D/DRC Case

2222 Main Street

**DESIGN/DEVELOPMENT REVIEW COMMISSION
DESIGN REVIEW DISTRICT**

Informational Presentation

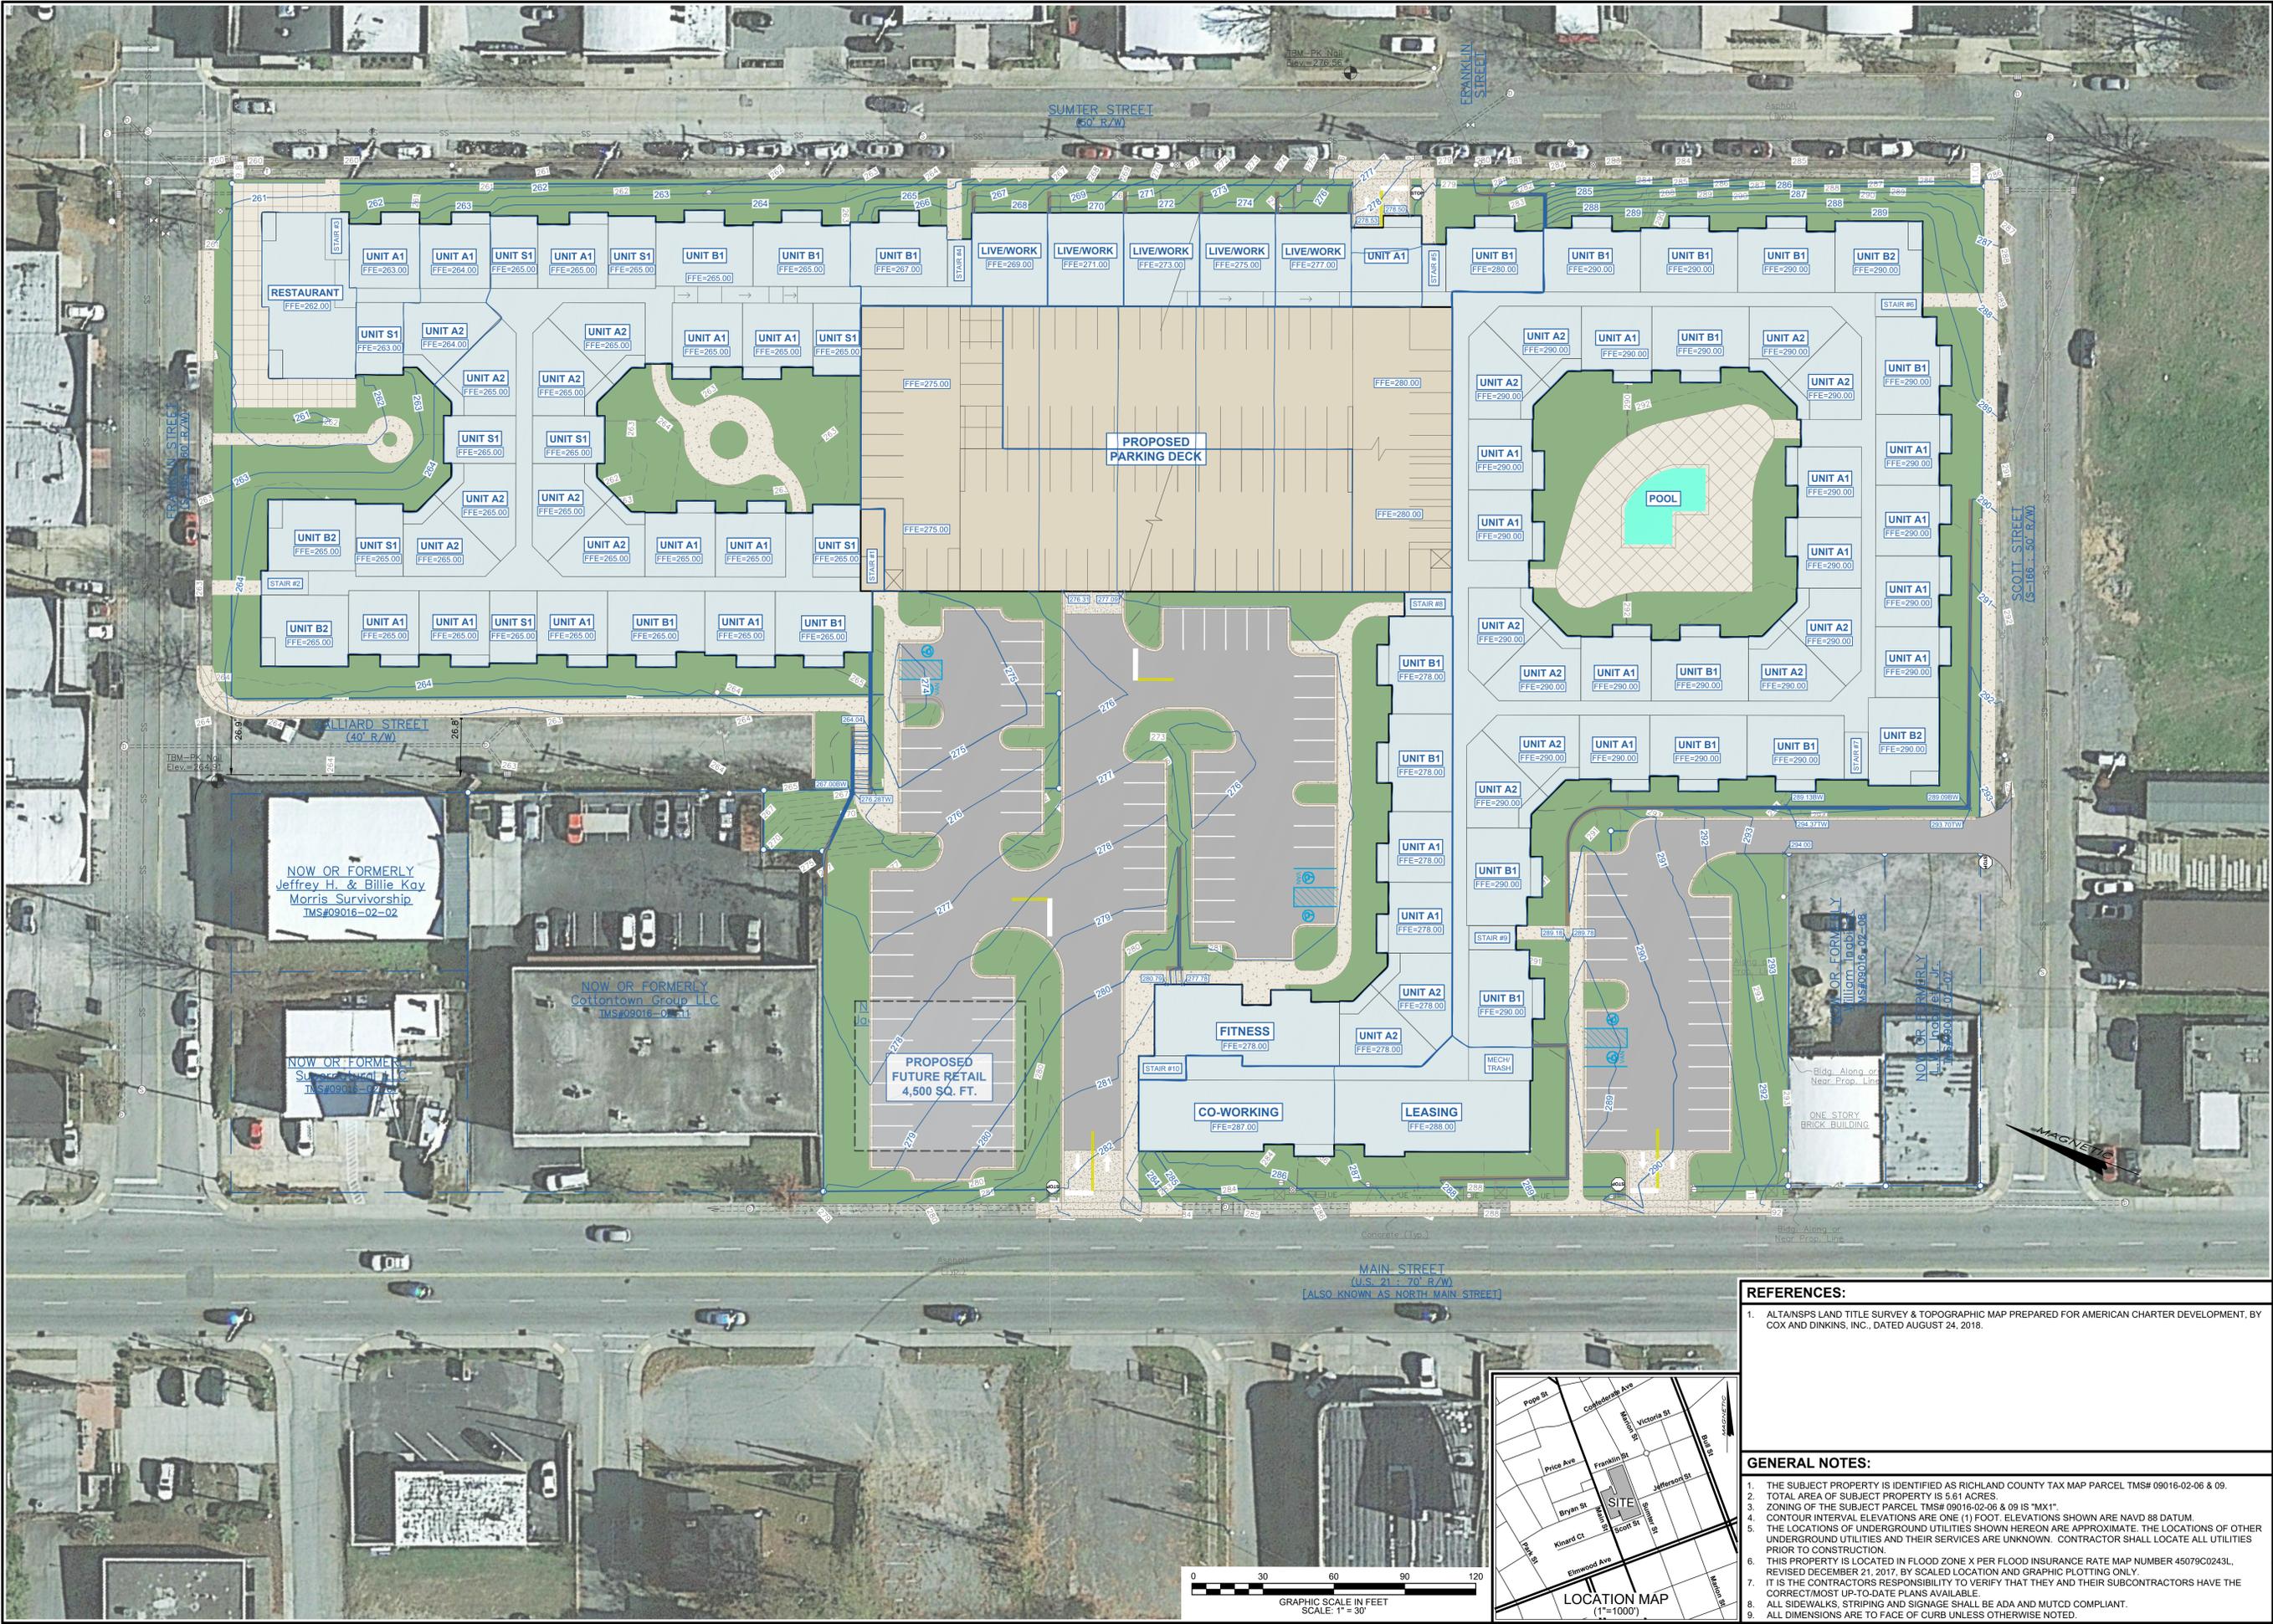
Upper floor windows percentages should be greatly increased to better articulate the façade, and all window sections should be designed to provide a substantial recess in the façade to articulate fenestration and provide interest. The A.01 rendering illustrates a consistent rhythm of recesses and projections along the street, a better proportion of fenestration and a simpler materials palette that works well with the massing of the building.
